ADVANCED SAFETY EVALUATION BY THE OFFICE OF NEW REACTORS  
 TOPICAL REPORT MUAP-07010-P, REVISION 4  
 "NON-LOCA METHODOLOGY"  
 MITSUBISHI HEAVY INDUSTRIES, Ltd  
 DOCKET NO. 52-021

Figure 1 MDNBR for the LOL Cases

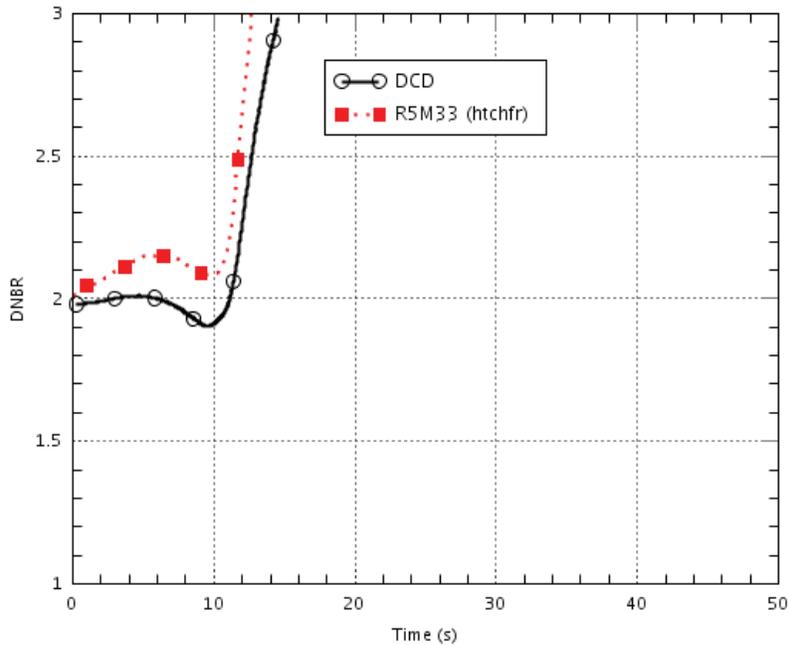
For the LOL event, the RELAP5/MOD3.3 LOL confirmatory runs showed good agreement with the MARVEL-M results presented in the US-APWR DCD. The MDNBR calculated by MARVEL-M was lower than that calculated by RELAP5/MOD3.3, as shown in Figure 1 below. The peak RCS pressure calculated by MARVEL-M was higher than that calculated by RELAP5/MOD3.3, as shown in Figure 2 below. The timing of events and the transient responses of key variables with RELAP5 were very similar to those calculated with MARVEL-M, as shown in Table 2 below. The RELAP5/MOD3.3 LOL confirmatory runs show that MARVEL-M results in the US-APWR DCD Tier 2 are conservative.

Figure 3 SGTR Event - Break Flow

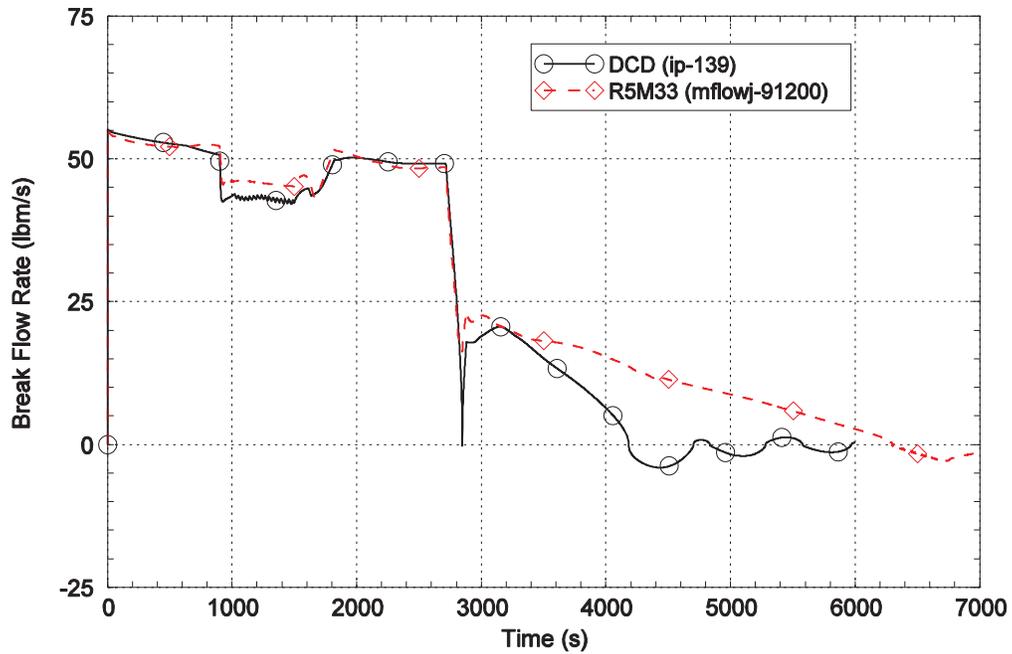
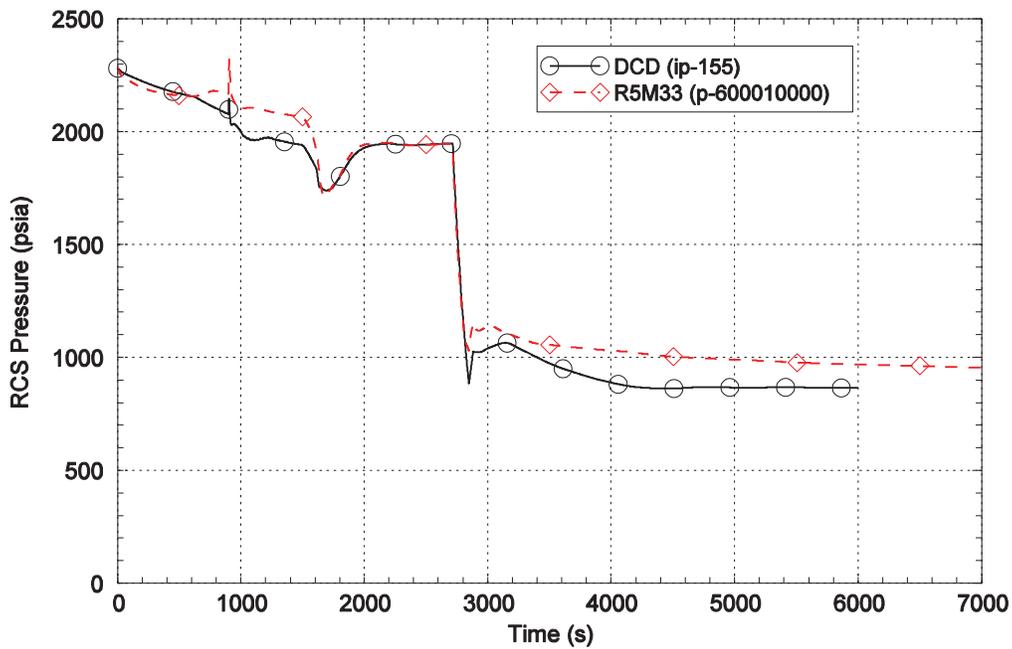
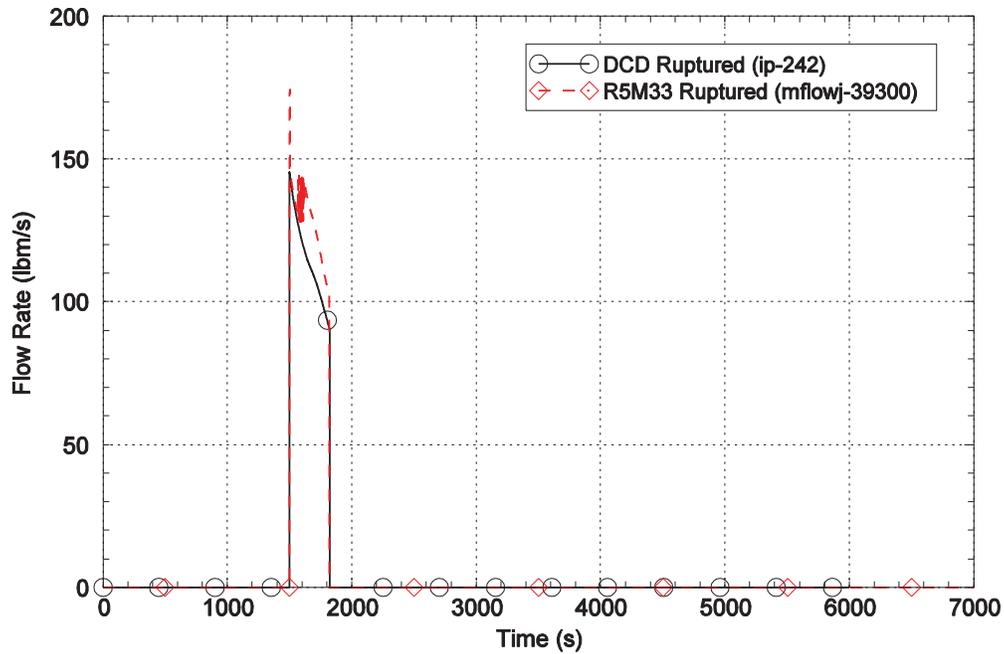
Thus, the goal of the confirmatory calculation was to see if MARVEL-M and RELAP5/MOD3.3 would give similar results when given the same initial and boundary conditions. Table 3 and Figure 3 through Figure 5 below show that the two codes provide similar results.

**Figure 6 MSLB Event - RCS Pressure**

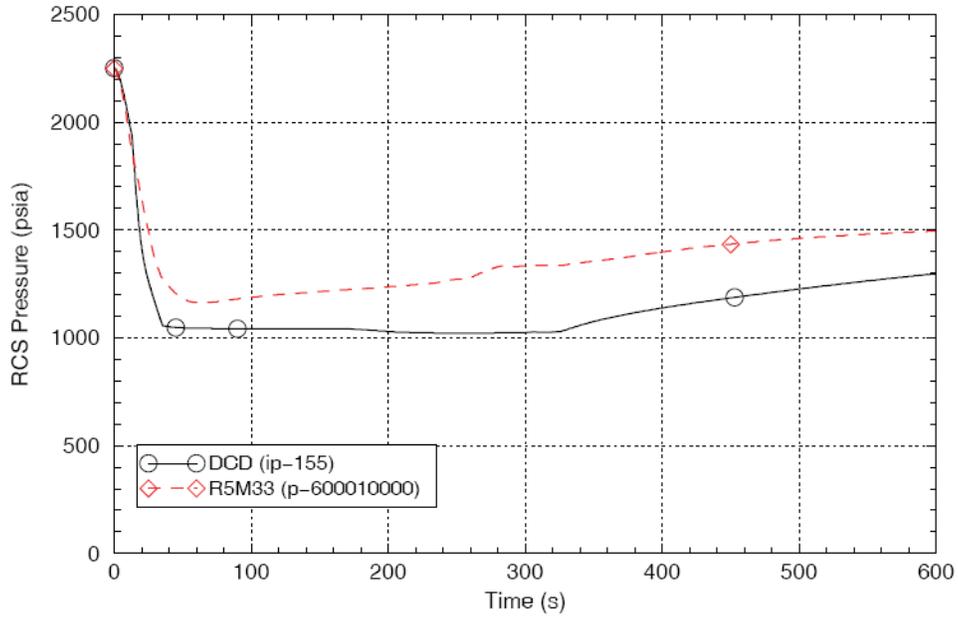
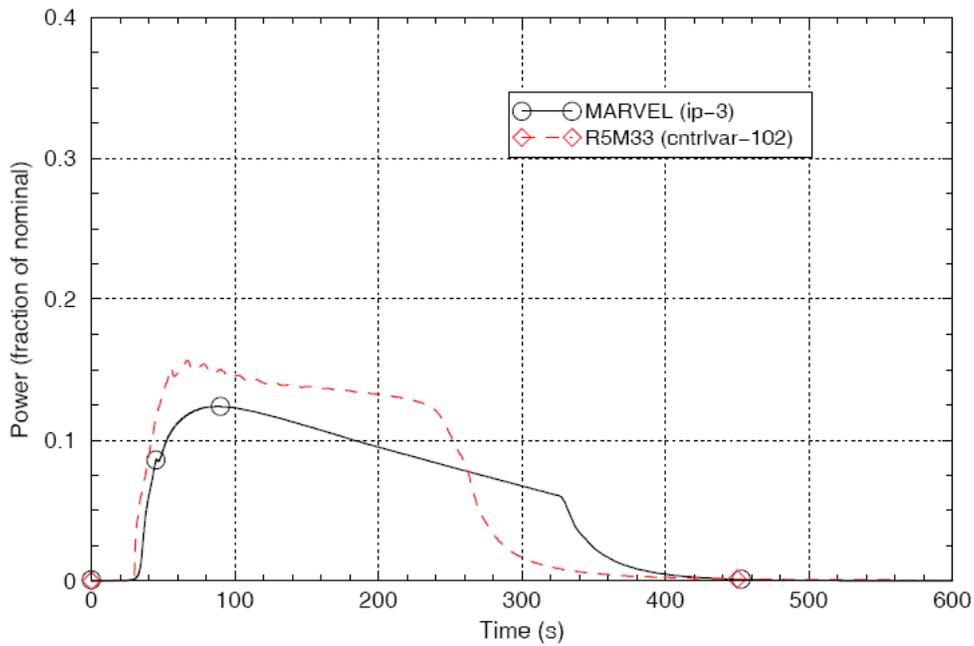
The RELAP5/MOD3.3 simulation of the HZP MSLB with RCPs running agreed closely with the MARVEL-M result. The main difference was that RELAP5/MOD3.3 calculated a slightly slower RCS pressure decline, as shown in Figure 6 below. This, in turn, caused SI injection to occur slightly later in the RELAP5/MOD3.3 calculation. In this MSLB event, the rise in core power is terminated by boron reaching the core; therefore, a delay in SI injection leads to a higher return to power. Whereas the US-APWR DCD Tier 2 calculation shows [ (Proprietary information withheld under 10 CFR 2.390) ], as shown in Figure 7 below. Technical Report ISL-NSAO-TR-10-01 [Ref. 25] does not identify a reason for the slight difference in the RCS pressure response with the two codes. A likely cause is that different models are used to compute the pressure in the pressurizer during a flow out-surge. This analysis demonstrates that the RELAP5/MOD3.3 MSLB confirmatory calculation is in good agreement with the corresponding MARVEL-M calculation in the DCD.
